DESCRIPTIVE REPORT

Type of Survey Hydrographic
Field No. RA-10-3-96
Registry No. H-10676

State Alaska
General Locality Southern Stephens Passage
Sublocality Spruce Island and Vicinity

**EVALUATION REPORT
H-10676**

CHART 17363
 11TH Ed. April 27, 1991
 Scale 1:40,000

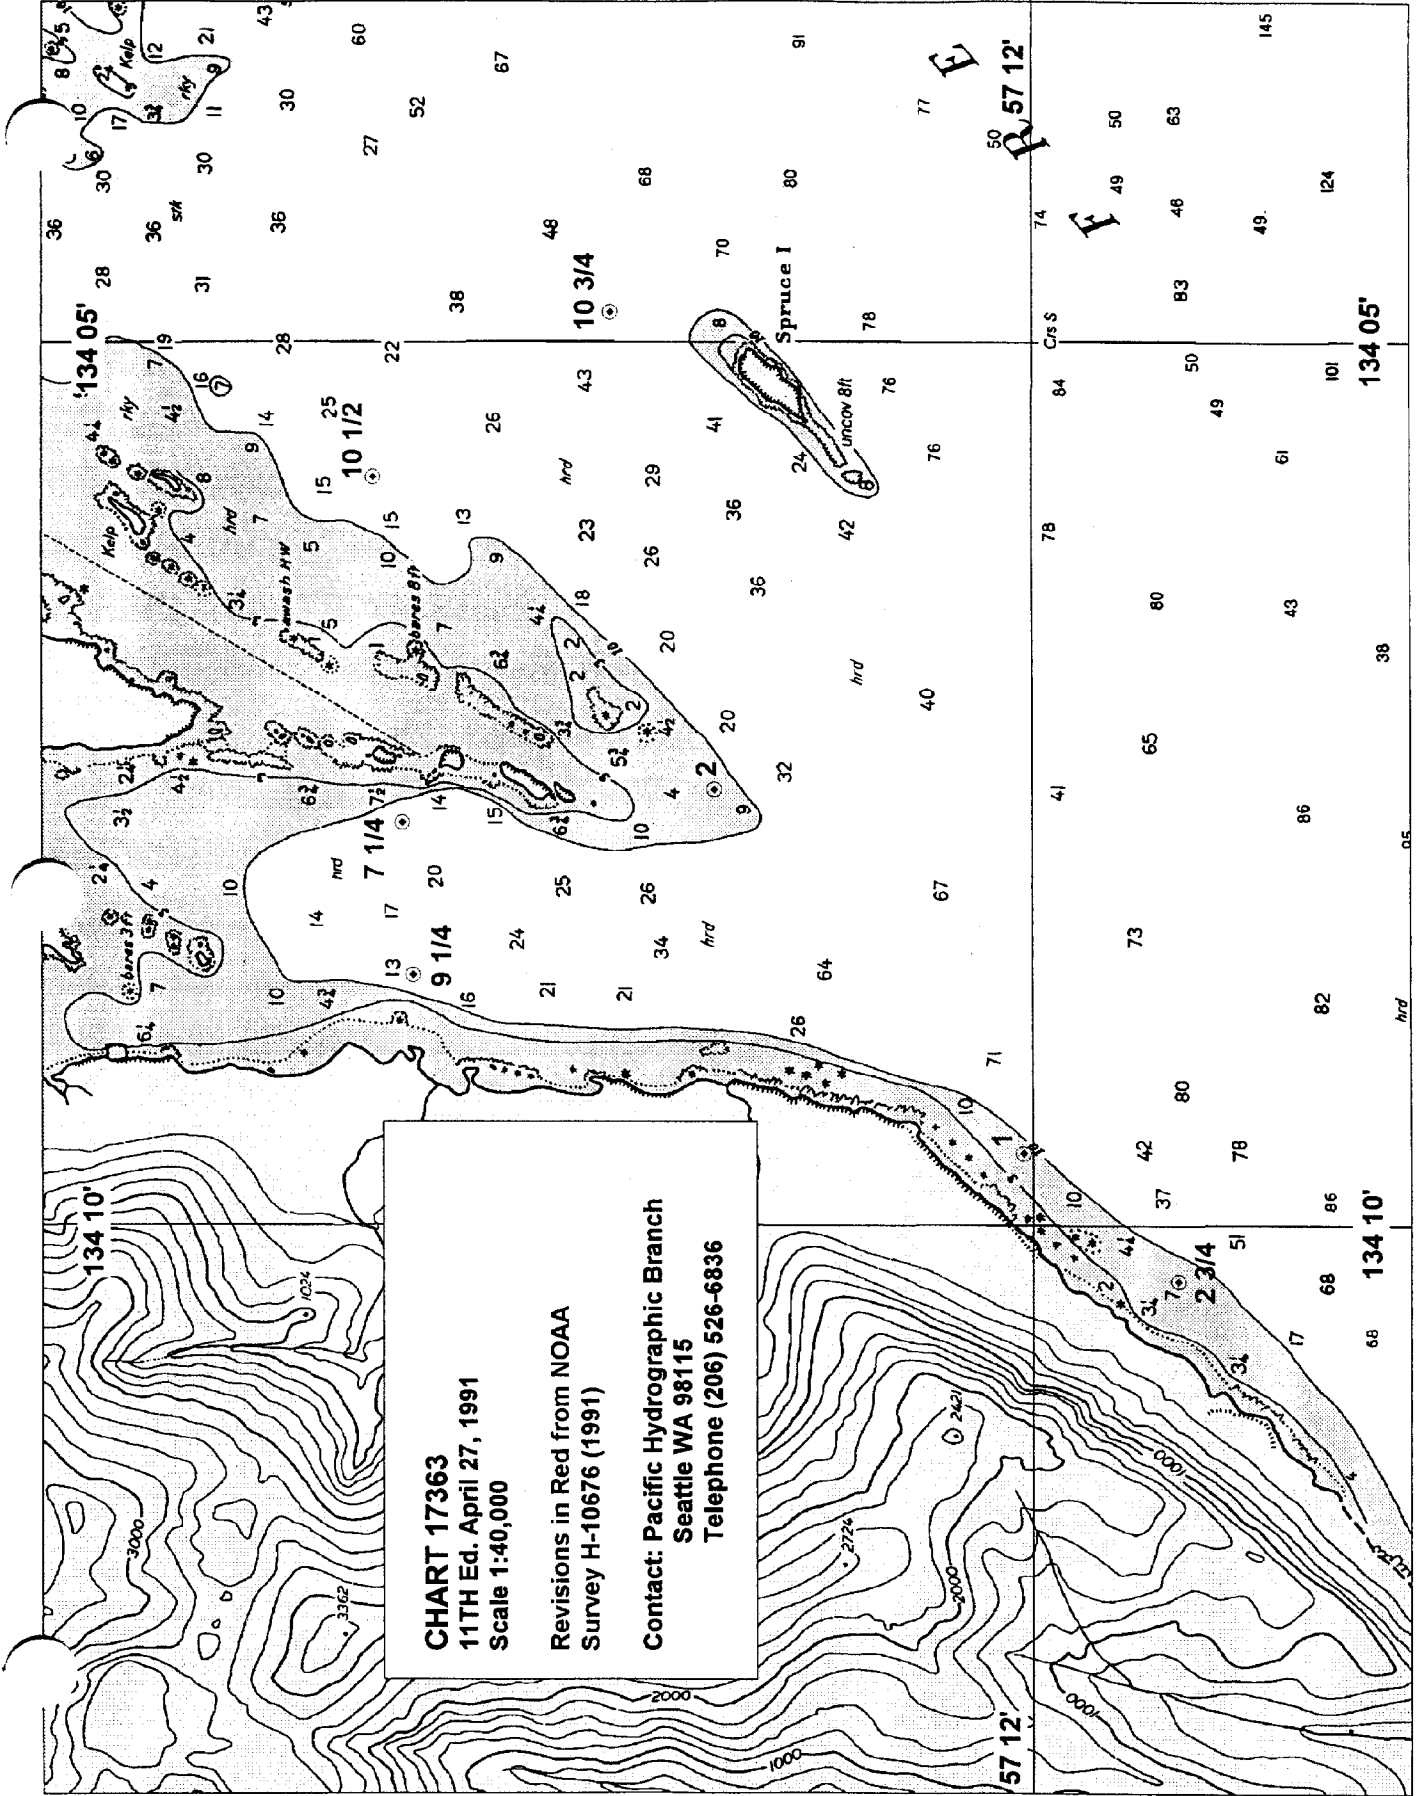
During office review of hydrographic survey H-10676, Alaska, Southern Stephens Passage, Spruce Island and Vicinity, seven shoal soundings were found and are considered potential dangers to navigation affecting the following chart.

<u>DANGER TO NAVIGATION</u>	<u>LATITUDE(N)</u>	<u>LONGITUDE(W)</u>
Shoal, covers 2 3/4 fathoms	57/11/35.08	134/10/18.62
Shoal, covers 1 fathoms	57/12/02.67	134/09/35.43
Shoal, covers 2 fathoms	57/12/57.55	134/07/31.88
Shoal, covers 9 1/4 fathoms	57/13/52.57	134/08/34.38
Shoal, covers 7 1/4 fathoms	57/13/54.27	134/07/43.18
Shoal, covers 10 1/2 fathoms	57/13/59.11	134/05/45.61
Shoal, covers 10 3/4 fathoms	57/13/16.00	134/04/49.85

Revisions in Red from NOAA
 Survey H-10676 (1991)
